TRACKSIDE GARDENS

WILSON EAST

Town Planning Application - RFI Response

Project Name 110 Wilson Street
Project Number 00013261
Project Address 110 Wilson Street
Moonee Ponds VIC 3039

Drawing Name
WILSON EAST
Detail Sections

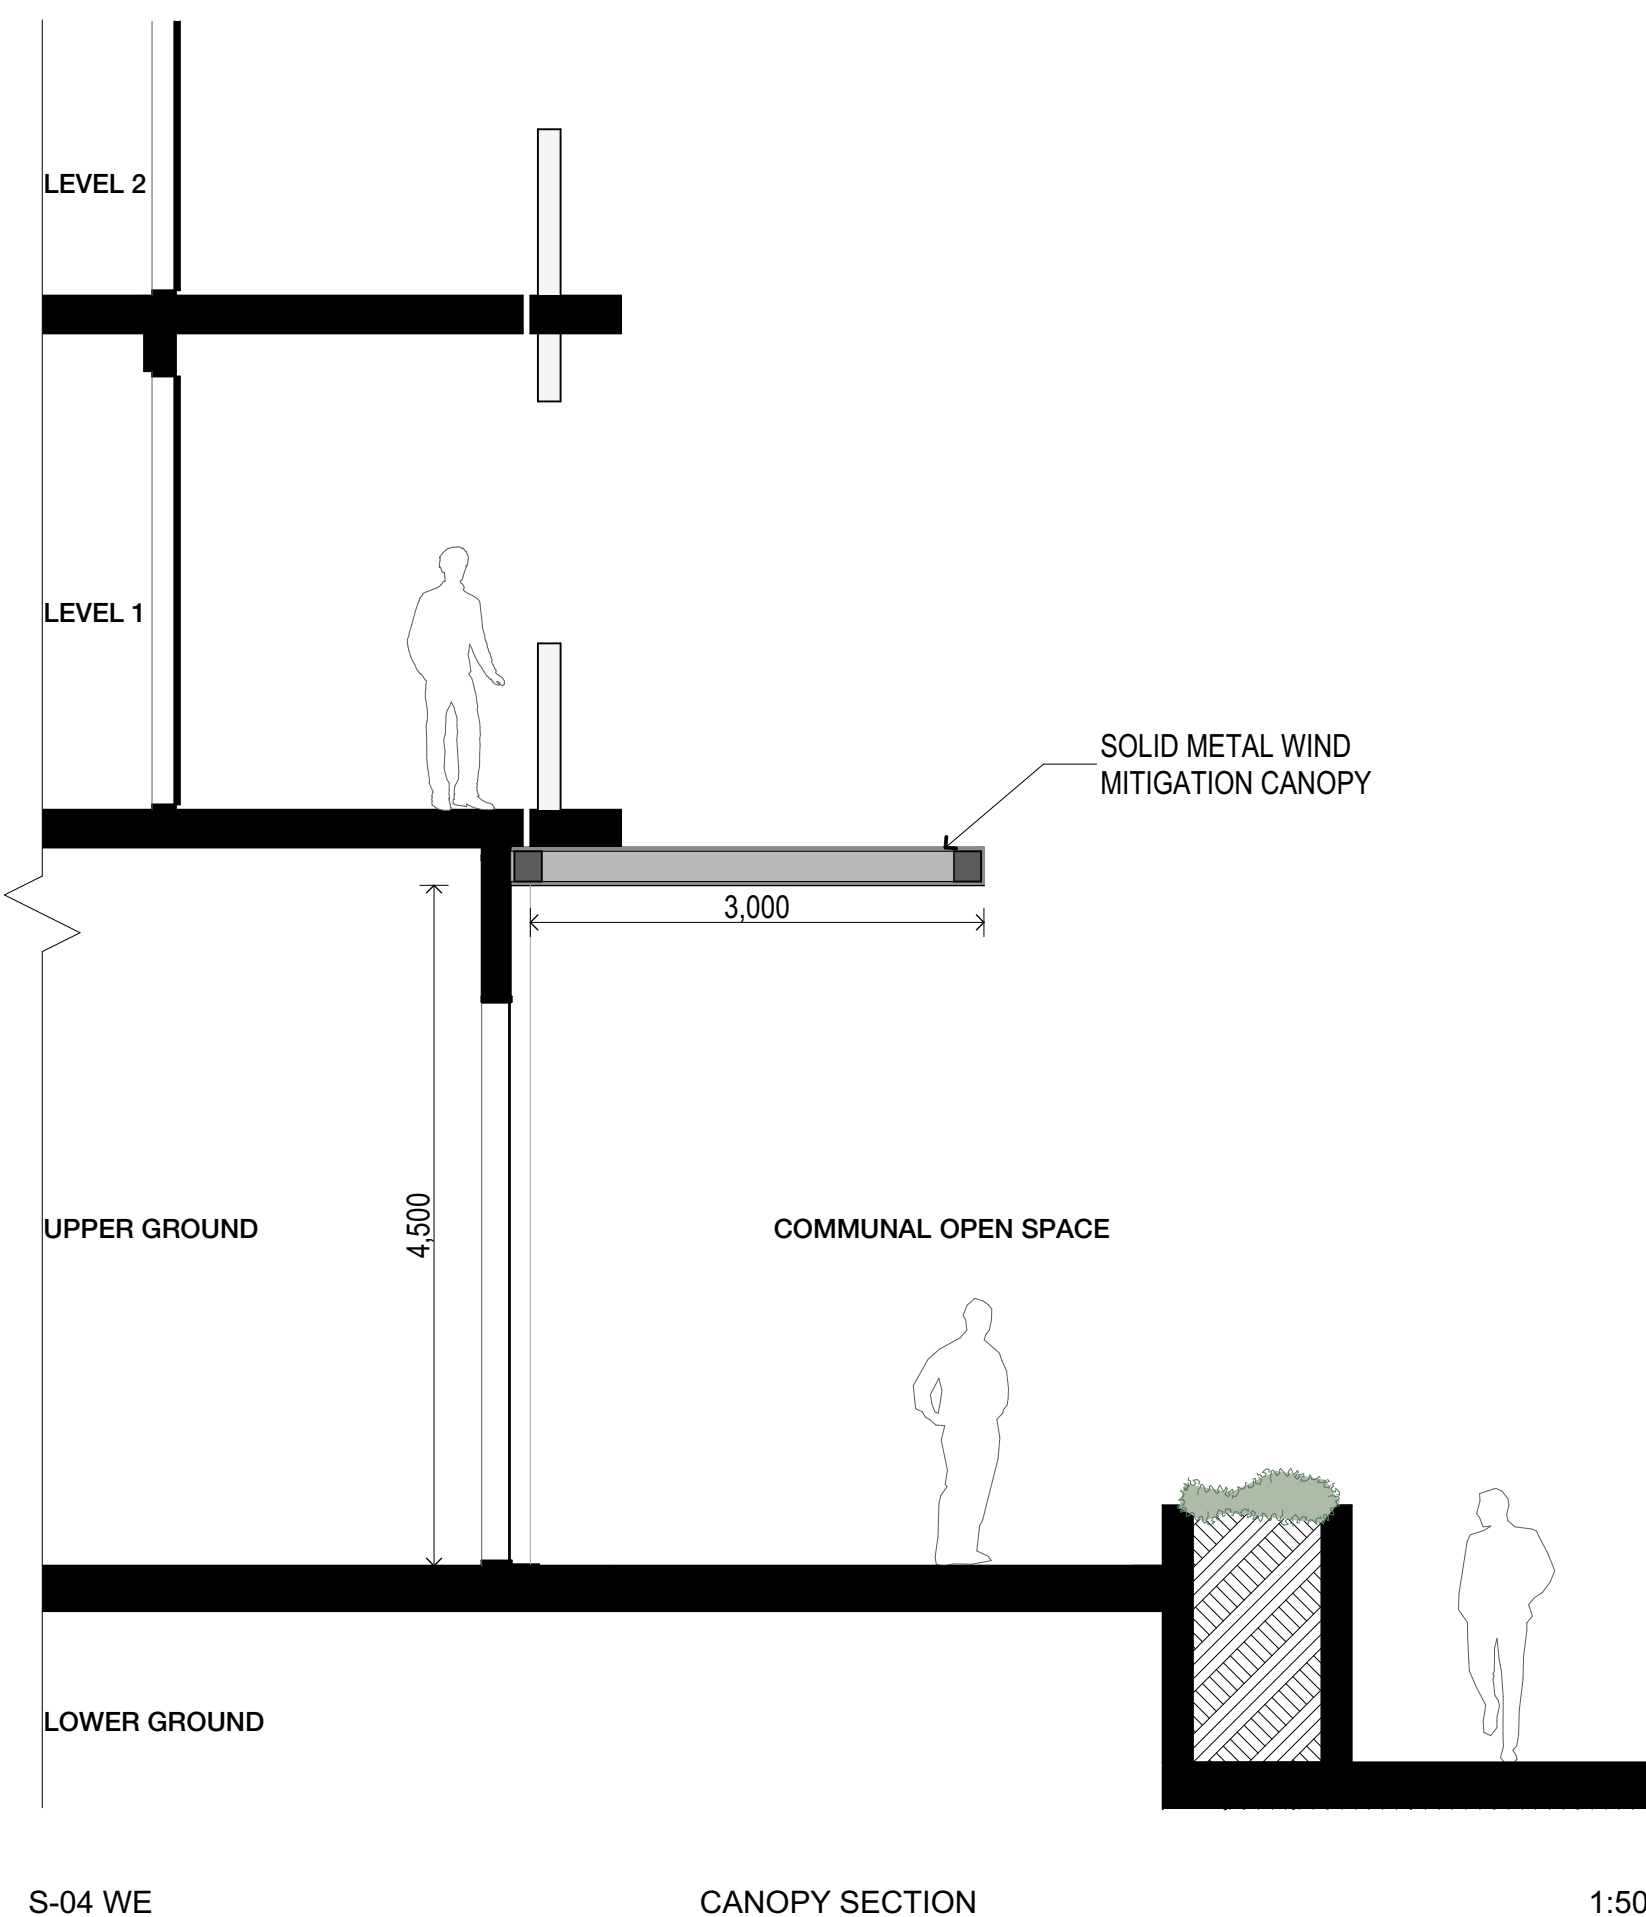
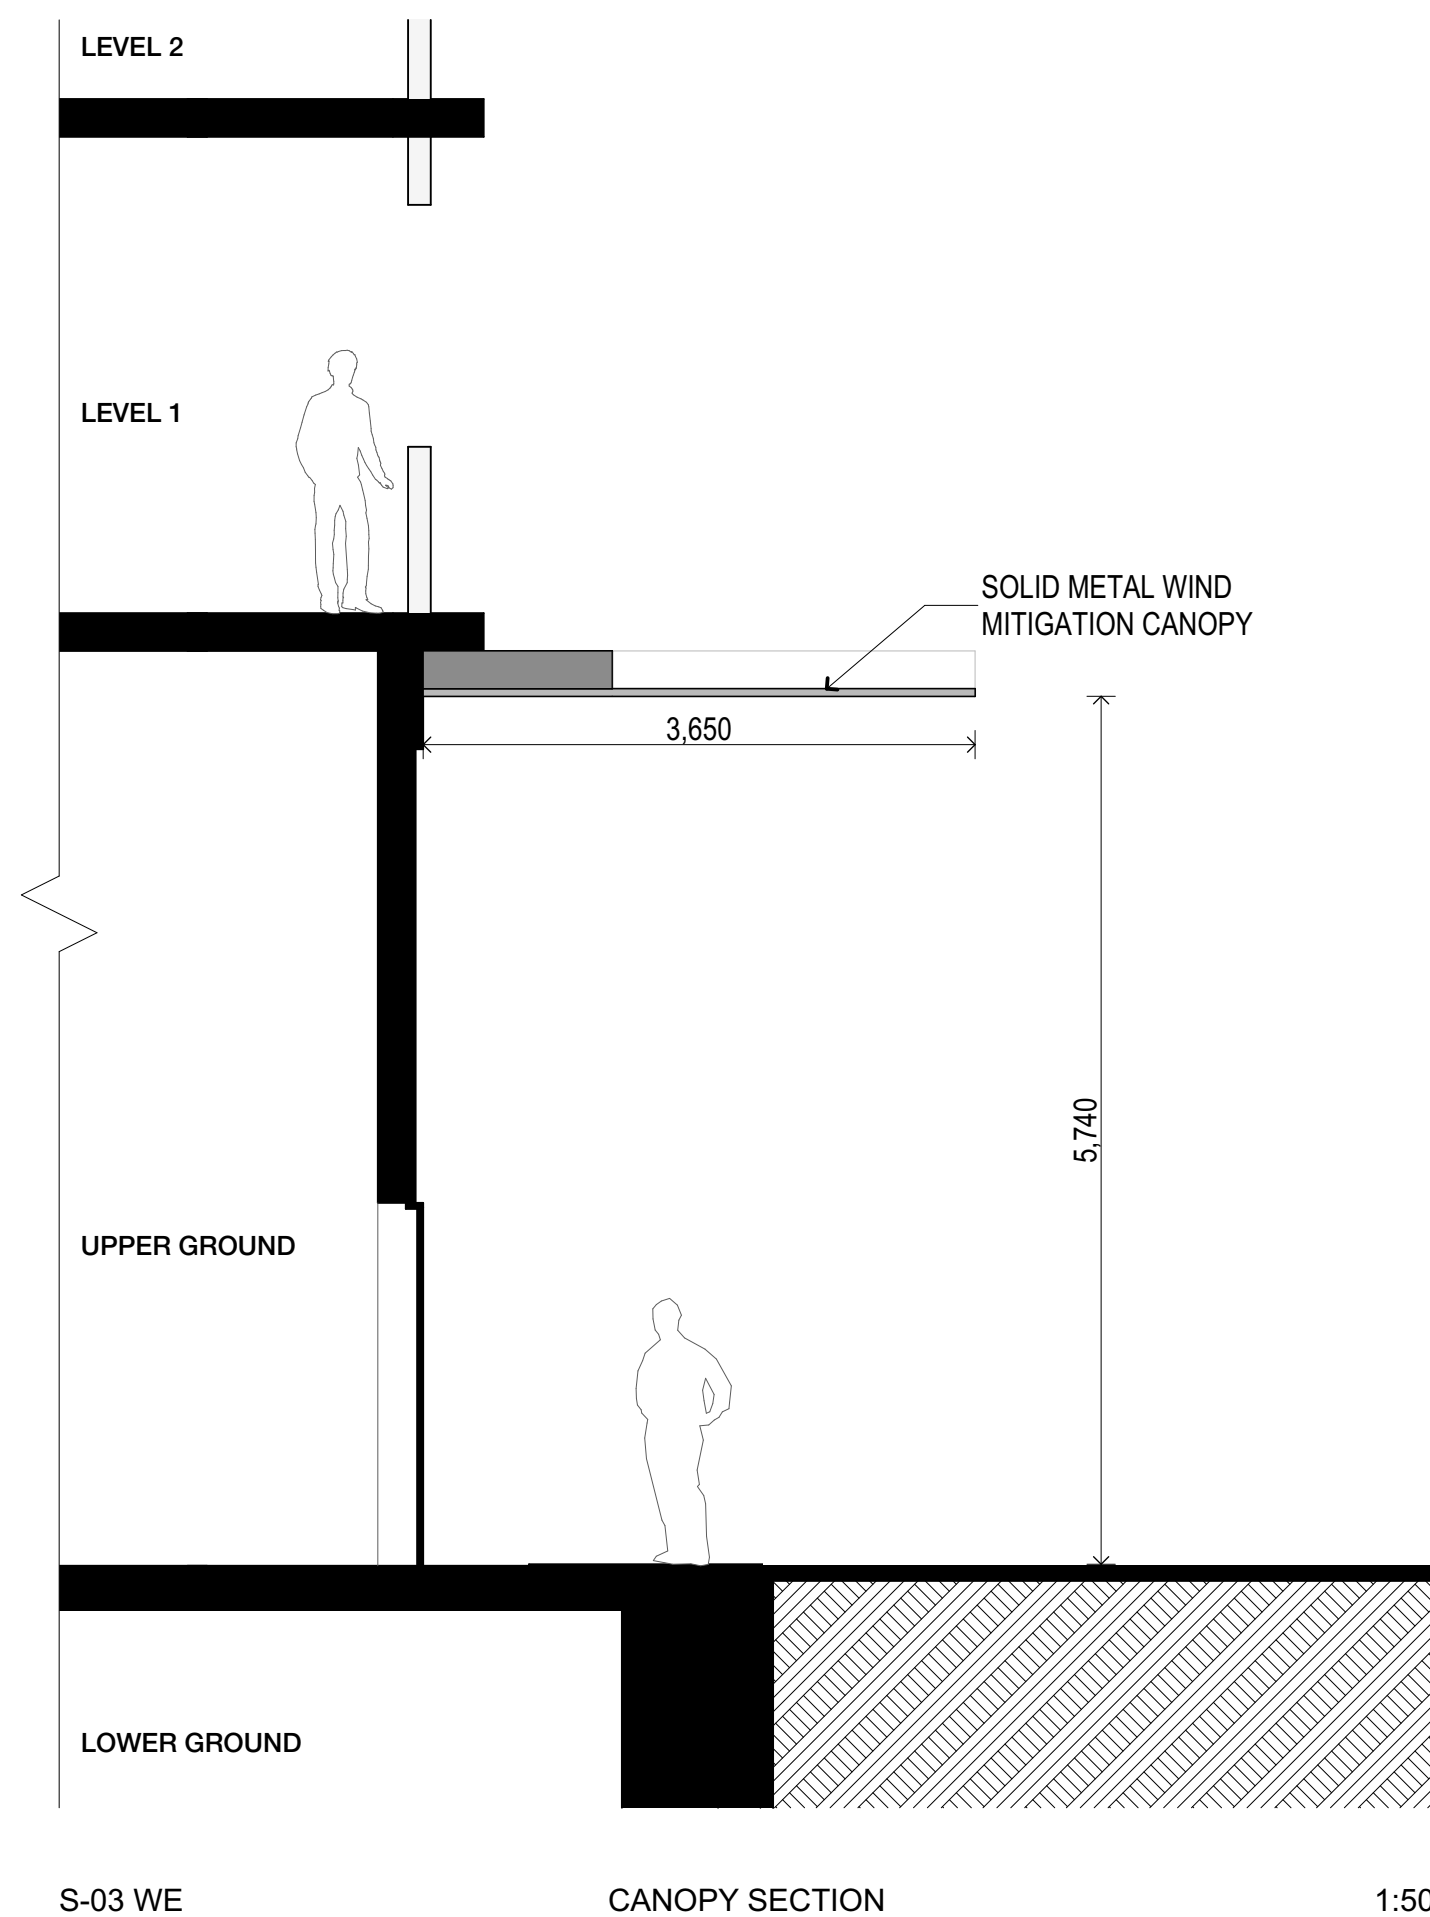
PA2604323 SECTION 54(1) RFI MATTERS
4.
b) All wind mitigation devices required per the recommendations of the Environmental Wind Speed Assessment, including details of materiality, height and cross-sections if necessary.
c) All recommendations/building performance solutions required by the Sustainability Management Plan, particularly those that will impact the appearance of the façade.

Drawing Name
WILSON EAST
Upper Ground

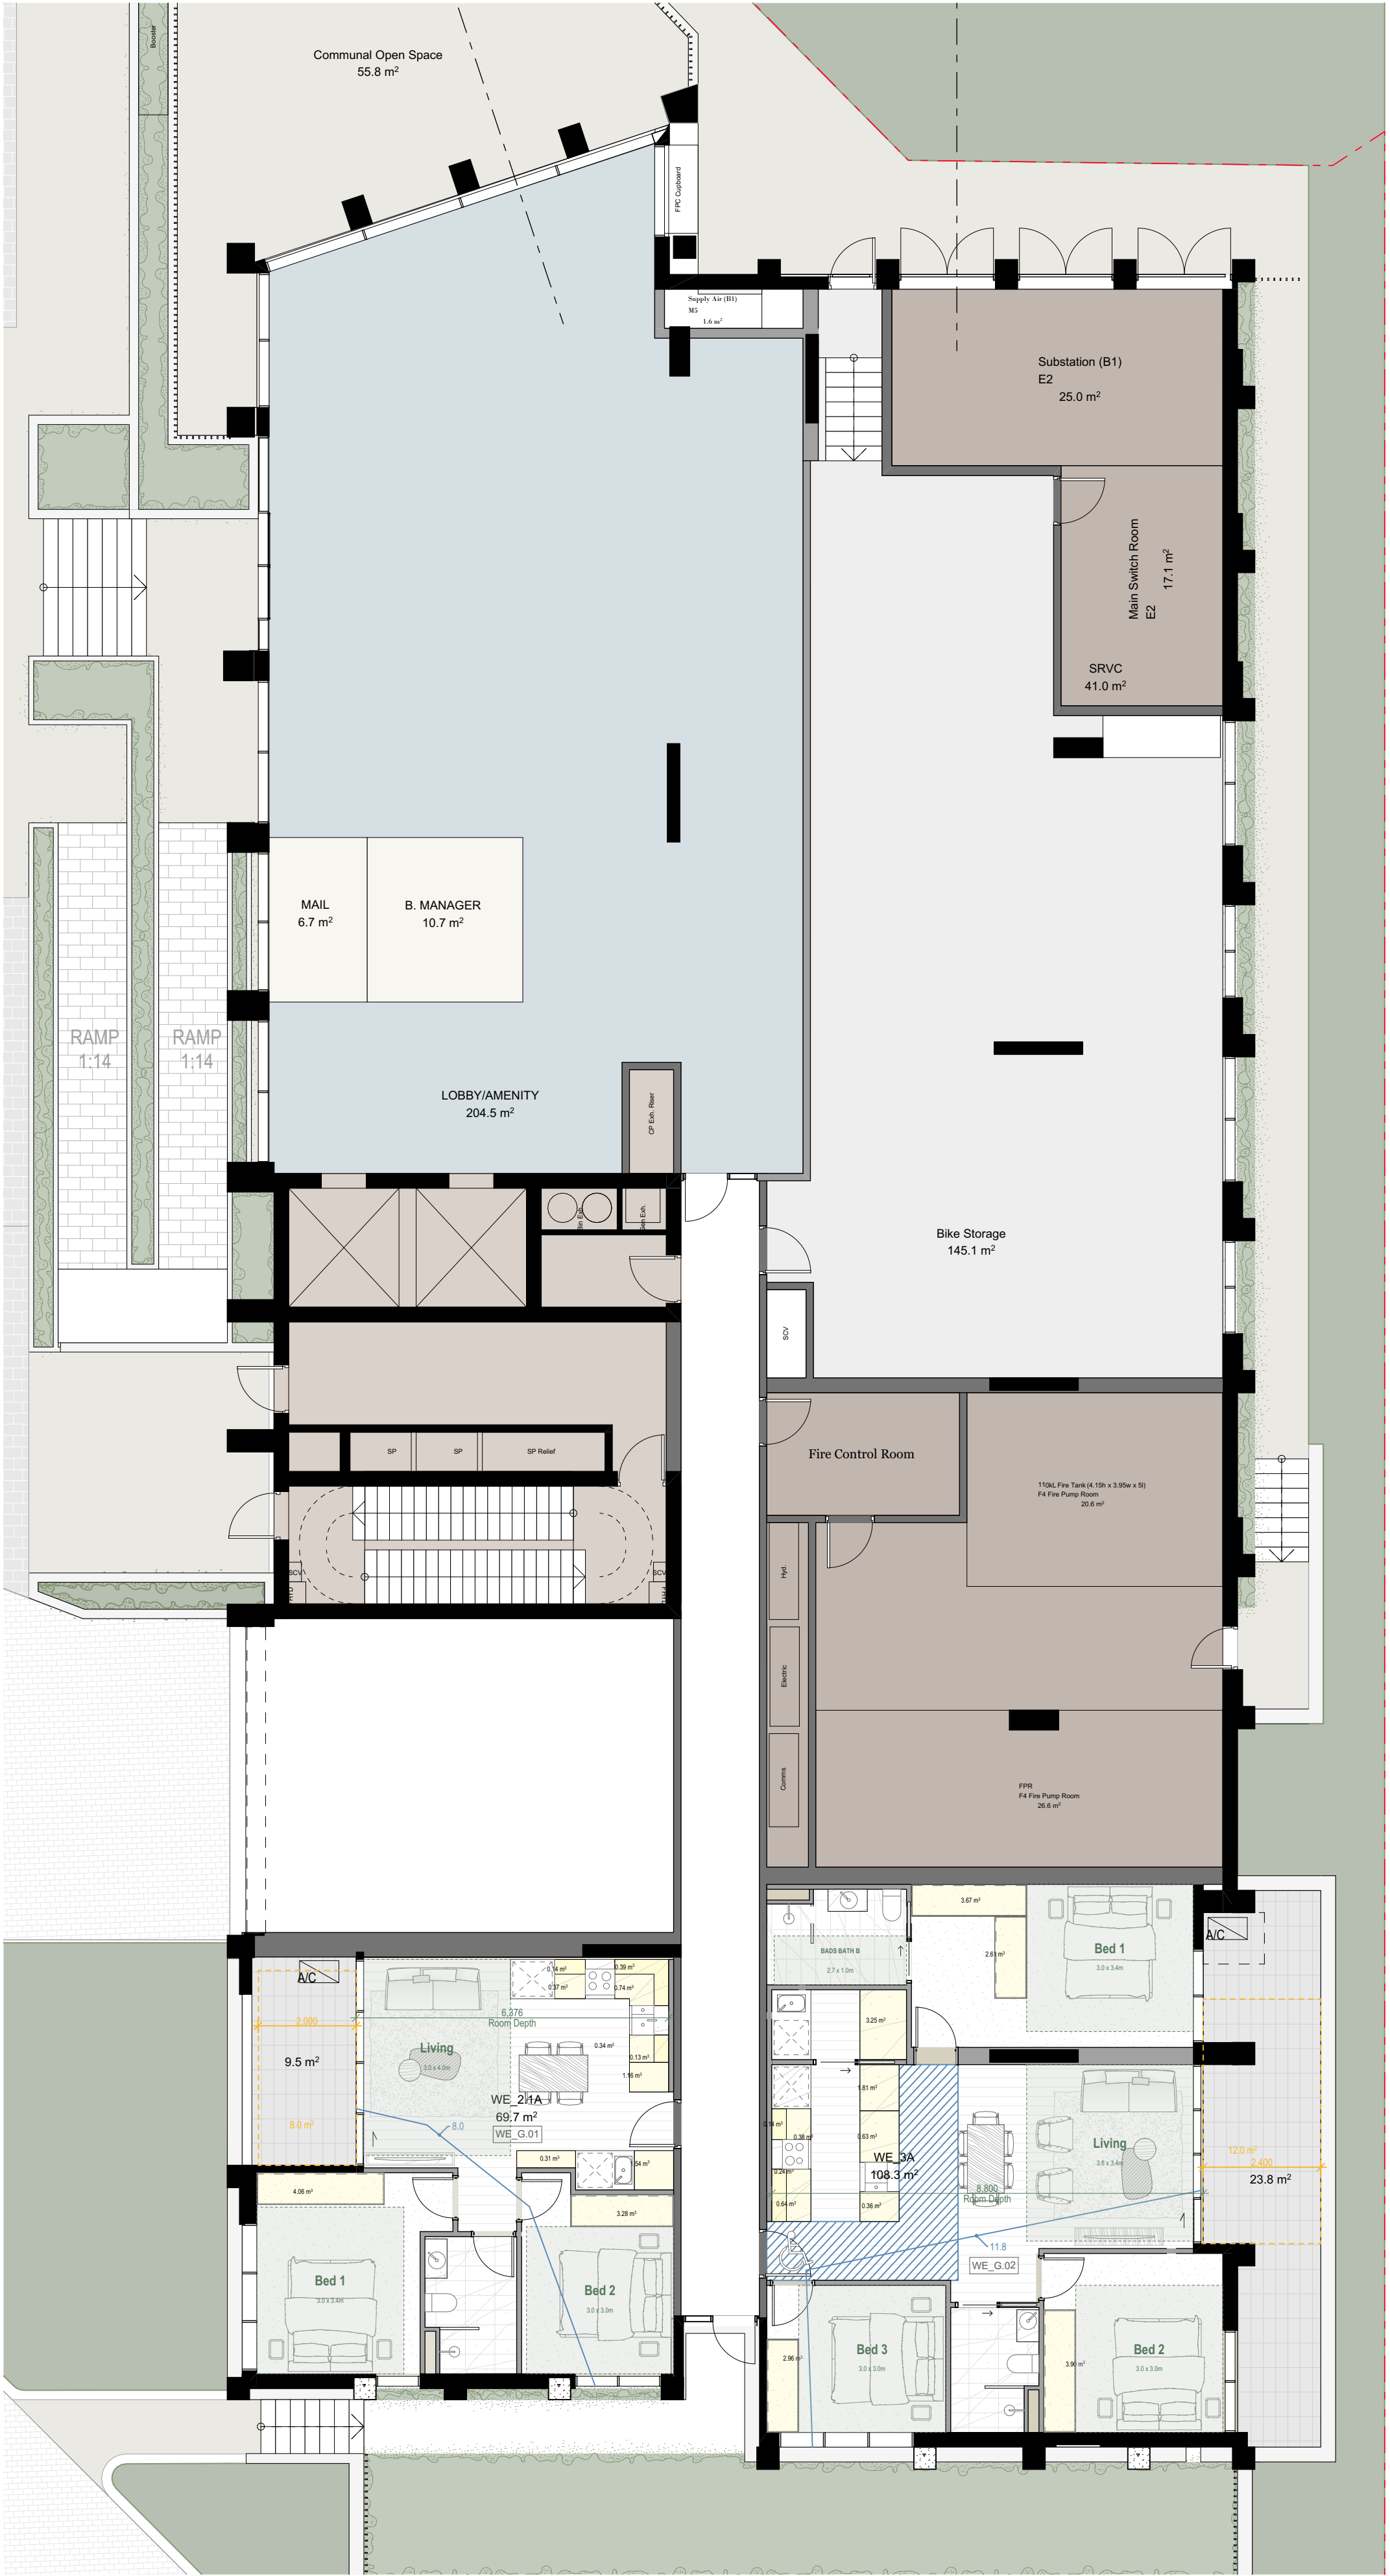
4. All recommendations/building performance solutions required by the Sustainability Management Plan, particularly those that will impact the appearance of the façade.
g) The Clause 58 assessment tables to itemise both the internal and total storage requirement for each dwelling per standard D20 of Clause 58 (Storage) to confirm compliance with both requirements and determine where external storage is required for any dwelling to meet the minimum total storage volume.
